Hydrodynamic and Water Quality Modeling

*(MEP Pleasant Bay Independent
Technical Review)*

May 7, 2009

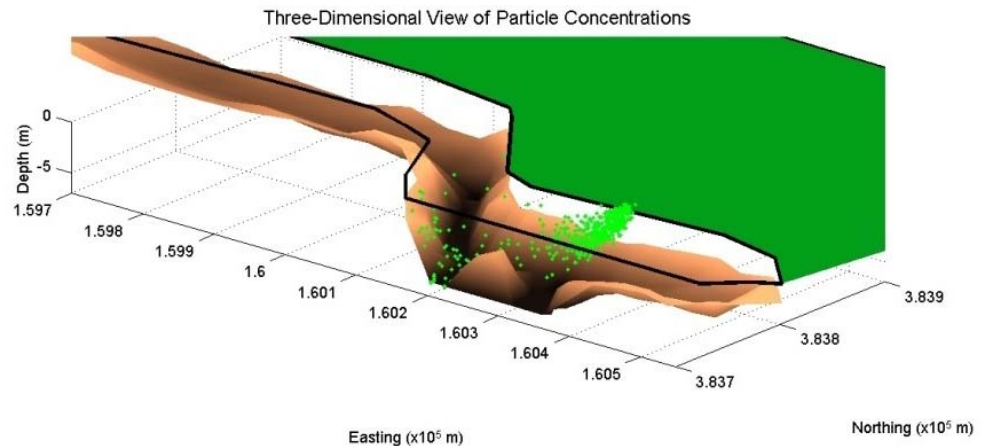
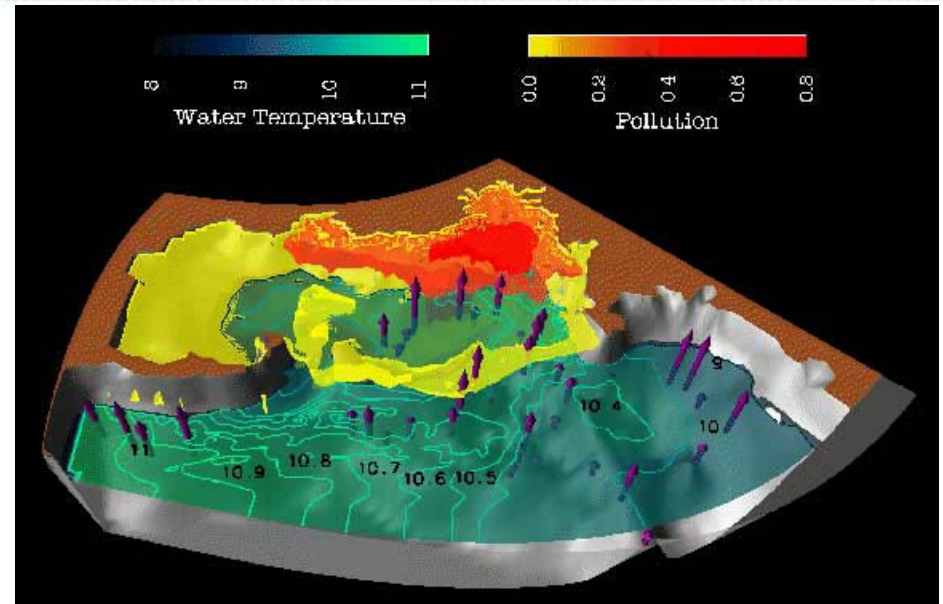
- RMA-2 Model is 2-D
 - Depth-averaged
 - Adequate for many cases
- Potential Stratification Effects
 - Constraint that slows renewal of dissolved oxygen
 - Two-layer estuarine circulation
 - Solar heating during the summer months

Data from Horne and Horne (2001)

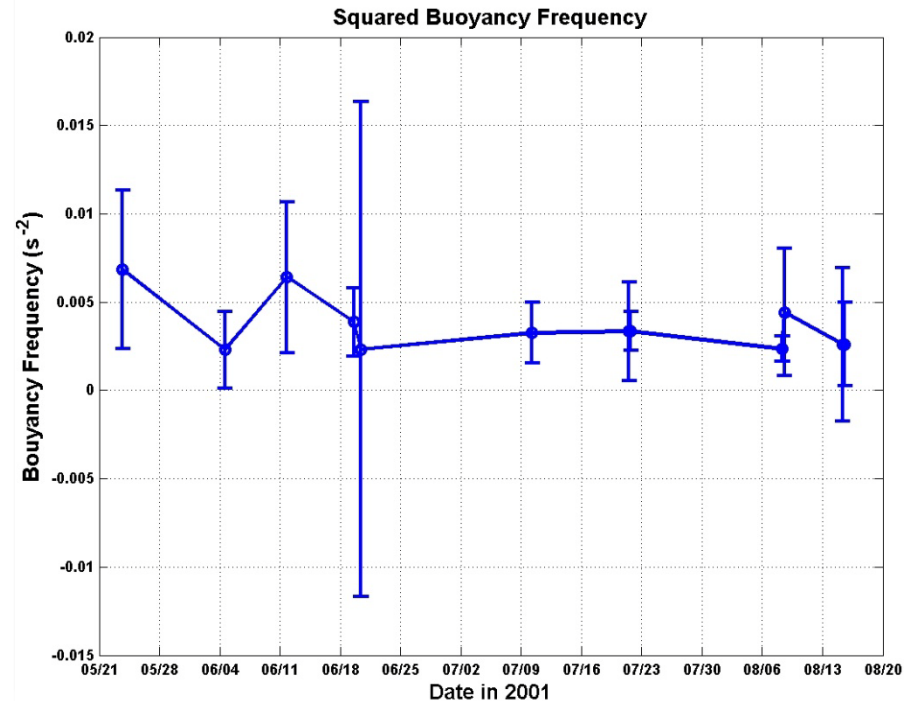
- Mean squared buoyancy frequency (Brunt-Vaisala) = $3.6 \times 10^{-3} \text{ s}^{-2}$
- Miles-Howard Criterion results in a required velocity of 0.24 m/s to overcome stratification
- Channel entrance velocity to Arey's Pond approximately $\frac{1}{2}$ of required velocity

Data from Horne and Horne (2001)

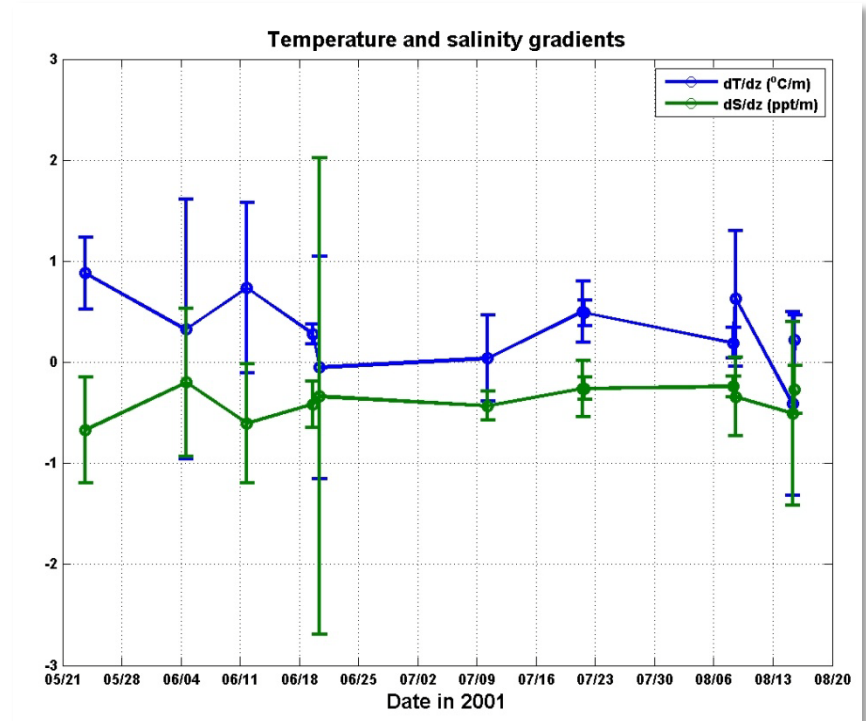
- Mean squared buoyancy frequency (Brunt-Vaisala) = $3.6 \times 10^{-3} \text{ s}^{-2}$
- Miles-Howard Criterion results in a required velocity of 0.24 m/s to overcome stratification
- Channel entrance velocity to Arey's Pond approximately $\frac{1}{2}$ of required velocity

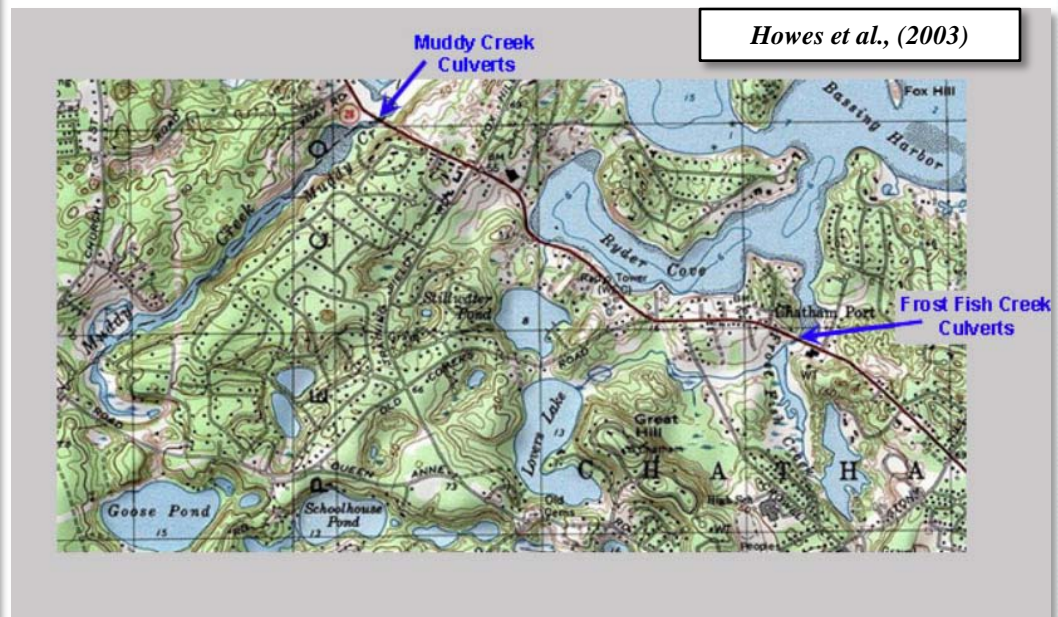
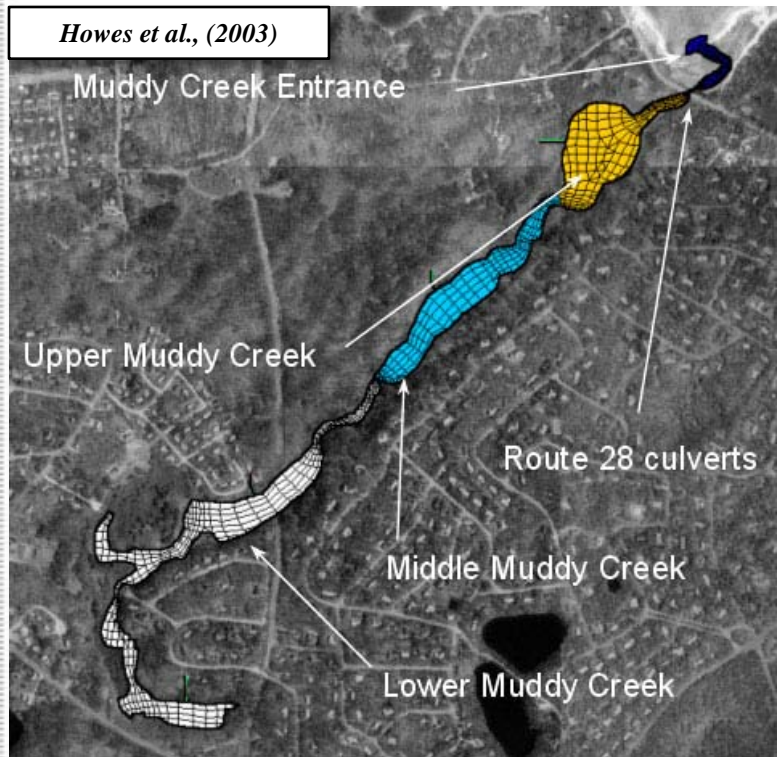
- Simulation of Anthropogenic Structures
- Does not directly influence Town of Orleans portion of Pleasant Bay

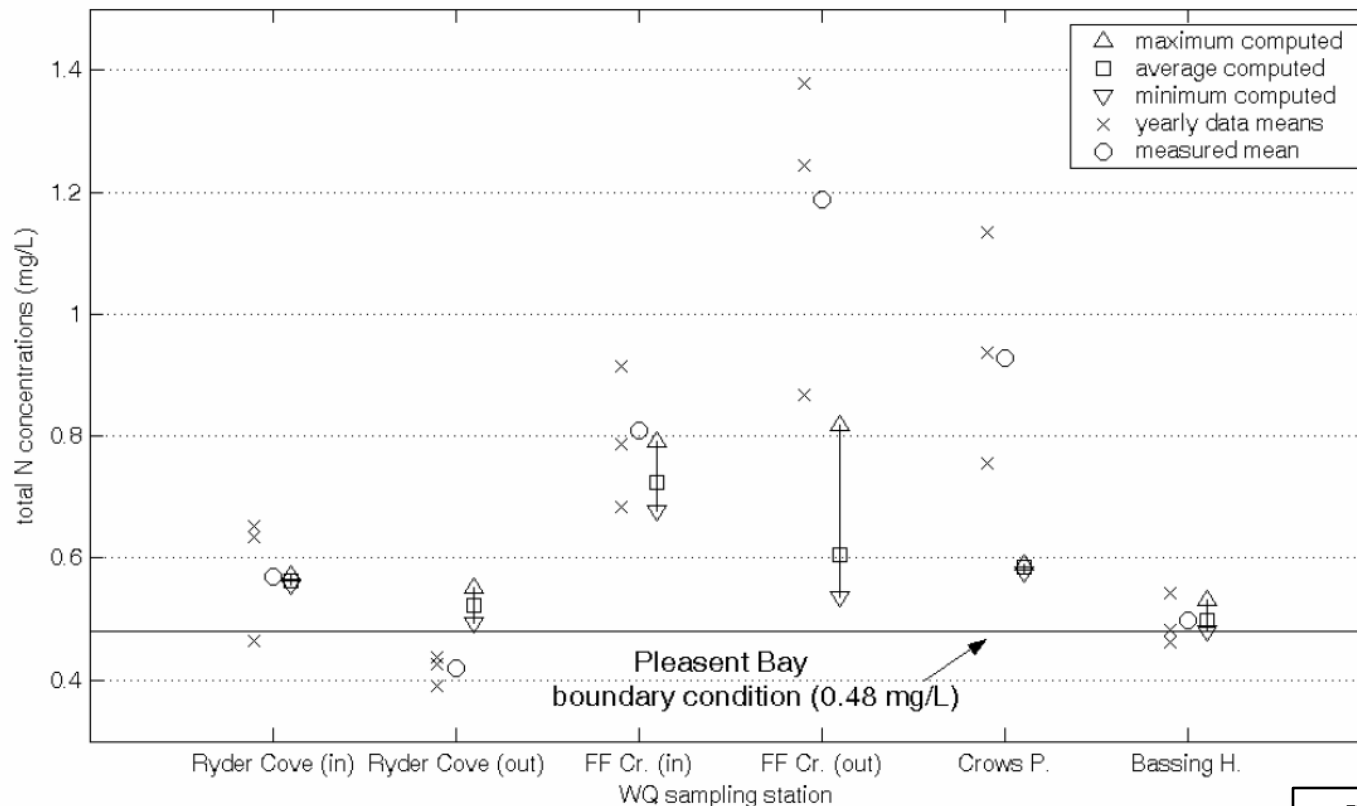
- Total vs. Bioactive Nitrogen
 - Bioactive approach only used for Pleasant Bay System
 - Loading boundary conditions are total nitrogen values

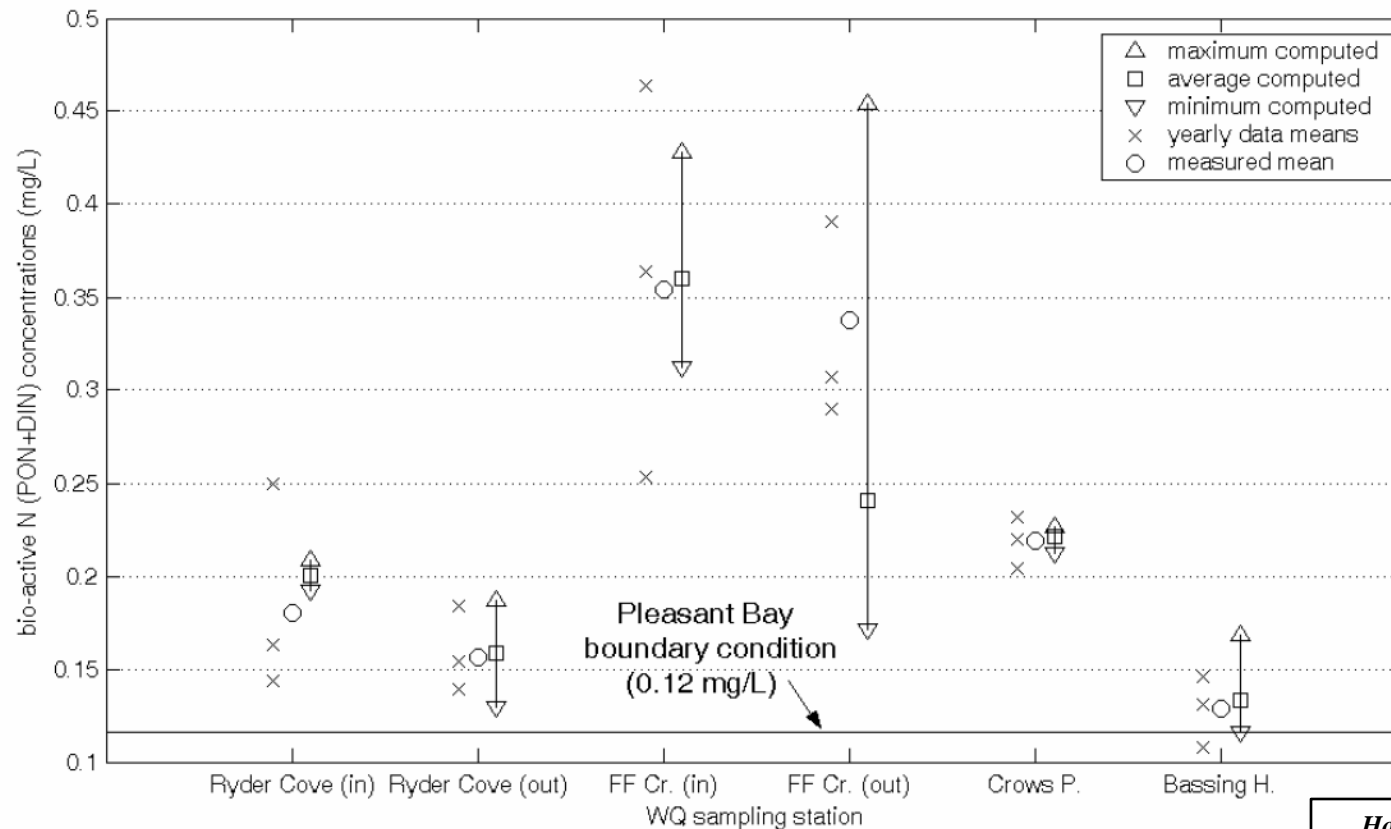
- Total vs. Bioactive Nitrogen
 - Bioactive approach only used for Pleasant Bay System
 - Loading boundary conditions are total nitrogen values

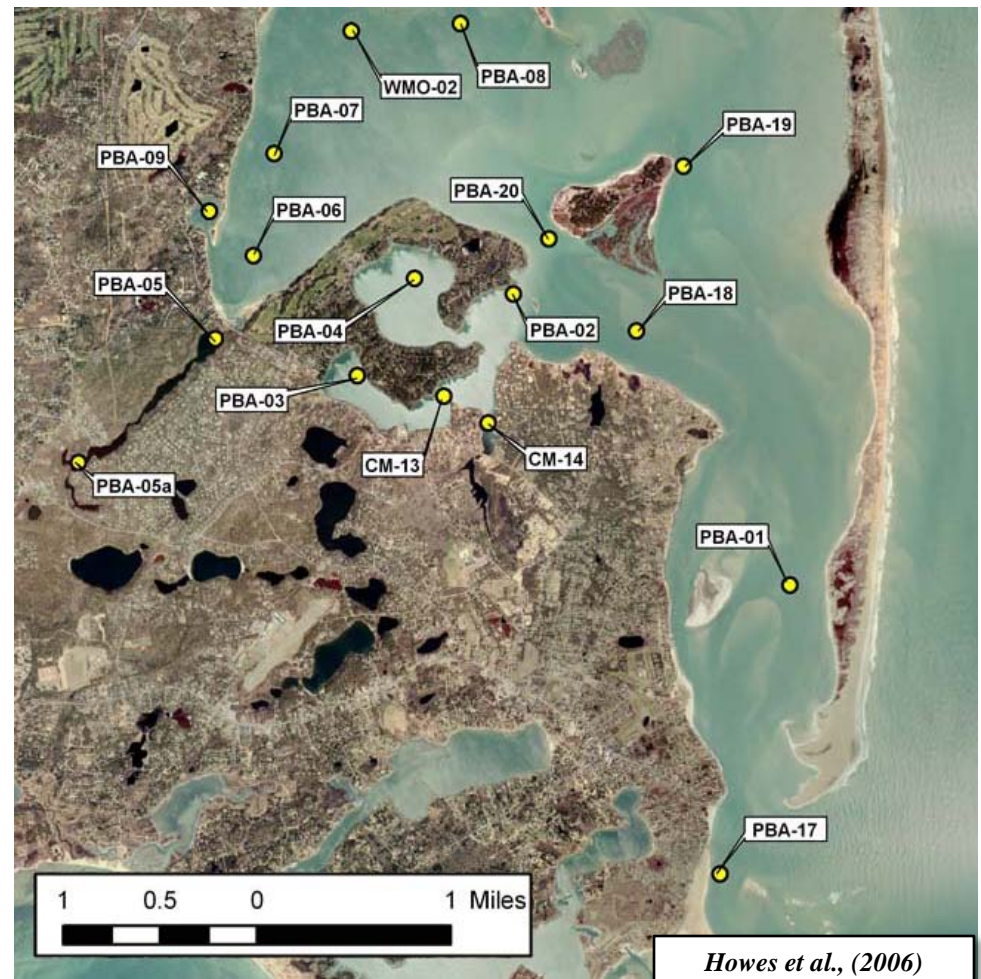
- Total vs. Bioactive Nitrogen
 - Bioactive approach only used for Pleasant Bay System
 - Loading boundary conditions are total nitrogen values

Calibration Techniques

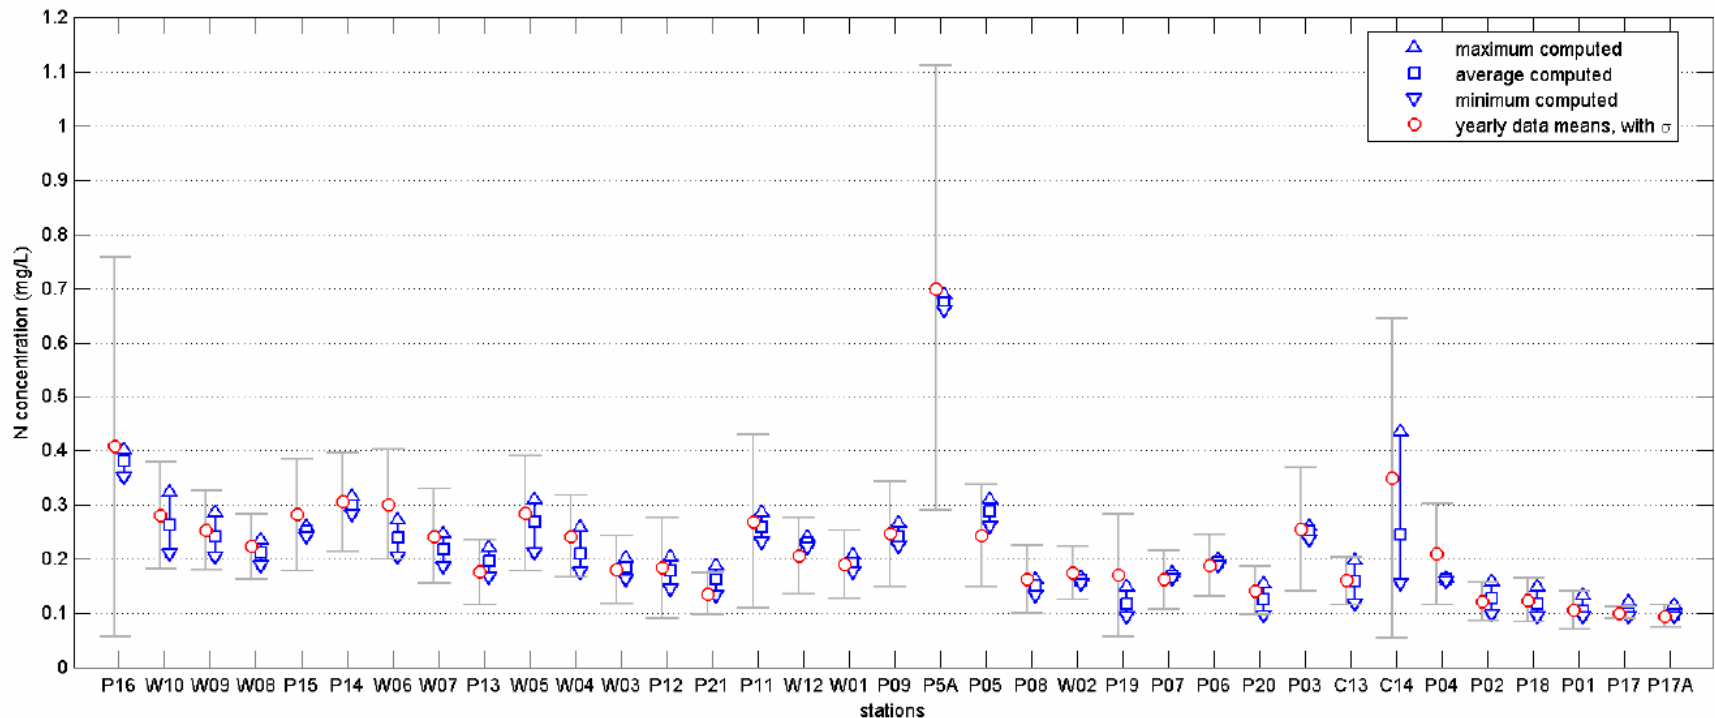
- Lack of time-dependent comparison
- Inconsistent methodology
- No assessment of maxima and minima
